SUBJECT: Forwards addl info re safety parameter display sys implementation plan submitted in response to Generic Ltr 82-33 & 840914 request. Info covers isolation devices, human factors program & data validation.

Re: St. Lucie Units 1 and 2
Docket Nos. 50-335 and 50-389
SPDS Implementation Plan and
Parameter Selection Report
Request for Additional Information

RESPONSE TO THE NRC QUESTIONS

Figure 1 Diagram of Online Monitoring of Isolators

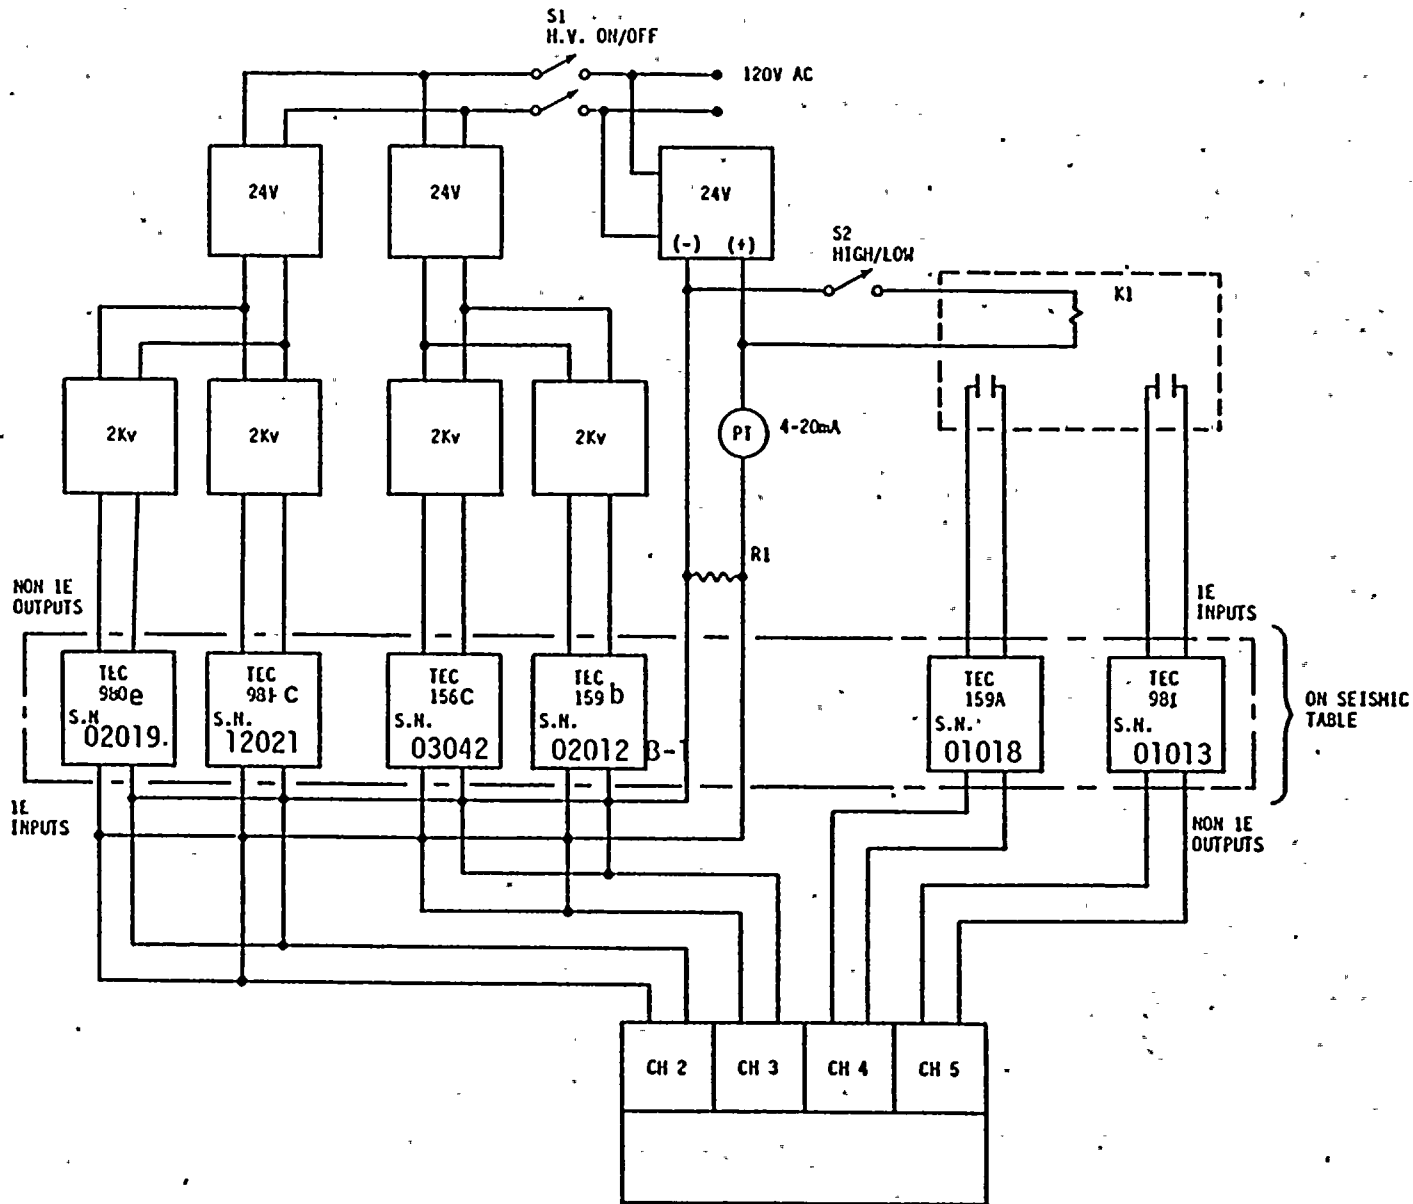
- a) The testing to demonstrate that the device was acceptable to accomplish electrical isolation was performed using 2000 V dc. This voltage was applied across the non-IE outputs during the seismic test. The IE input side of the isolators (Figure 1) was monitored to see that no breakdown occurred. Figure 2 shows the test configuration and the manner in which the maximum credible faults were applied. The model 981 digital isolators were functionally tested for high and low output during the second SSE. The output of the recorders during the 2000 V dc test is shown in Fig. 3. The chart shows that there was no effect on the isolator.

- c) Figure 1 "Diagram of On-Line Monitoring of Isolators page 16 from TEC test report 30152-TR-02 and Figure 2 "Isolation Capabilities test of 2200 Isolation System" from TEC procedure number 30152-DVTP-01 show that the signals were applied to the TEC isolator devices in the transverse mode and open circuit mode. It is also apparent from the block diagram of the analog and digital isolators (Figures 4, 5, 6 & 7) that any short on the output side would not pass through the opto isolator in the digital 981 and 159 isolators or the demodulator section of the analog 980 isolators and 156.

FIGURE 2

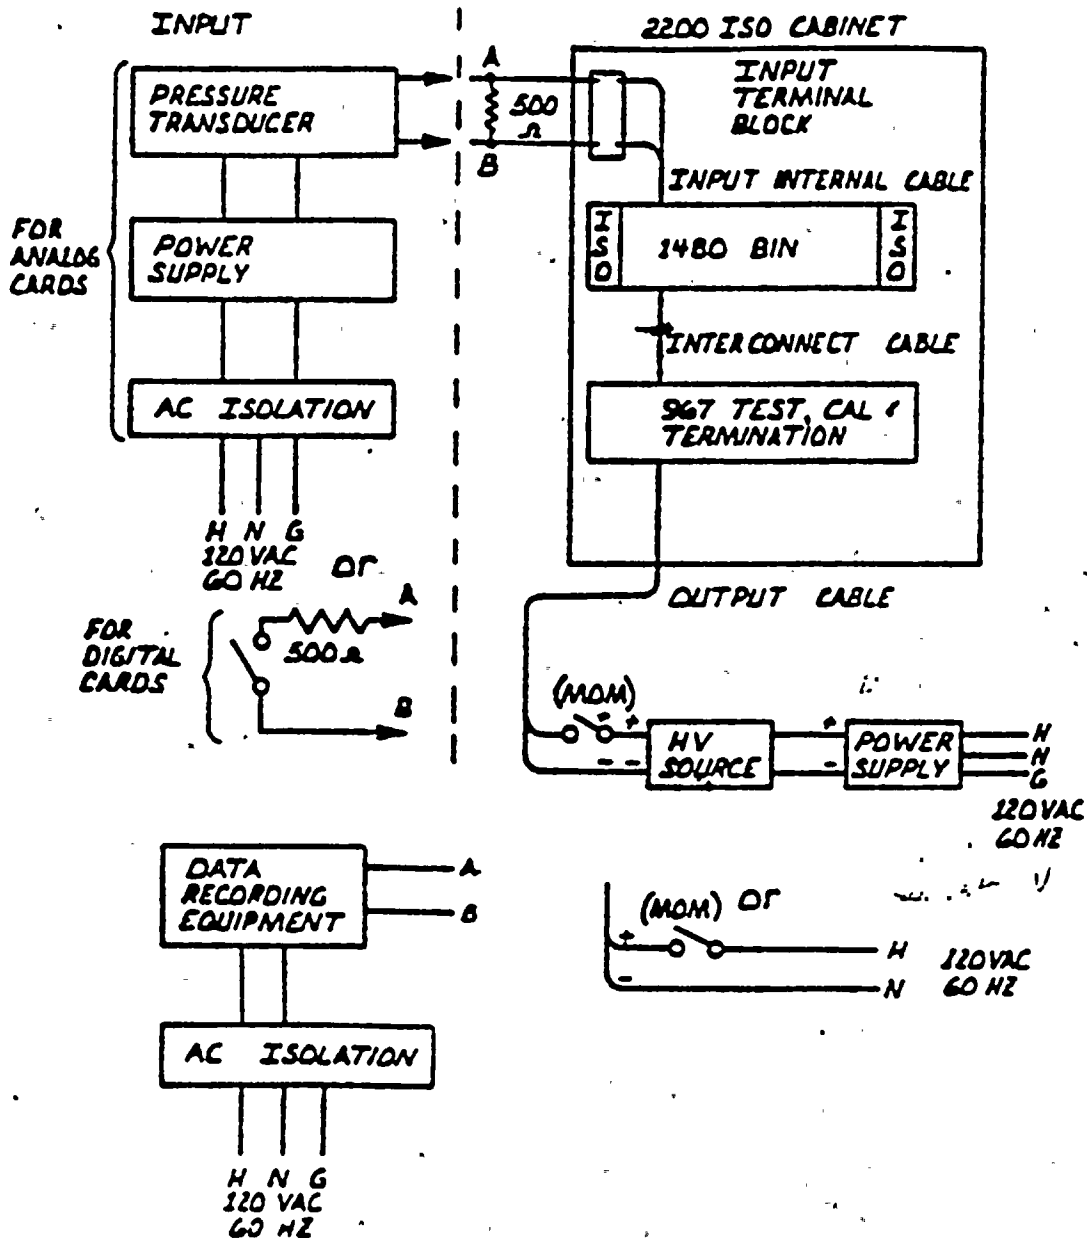
Digital isolators were also tested using the Fig. 2 arrangement by applying 2000 V dc. Once again there was no effect on the input or class IE side of the isolator noted.
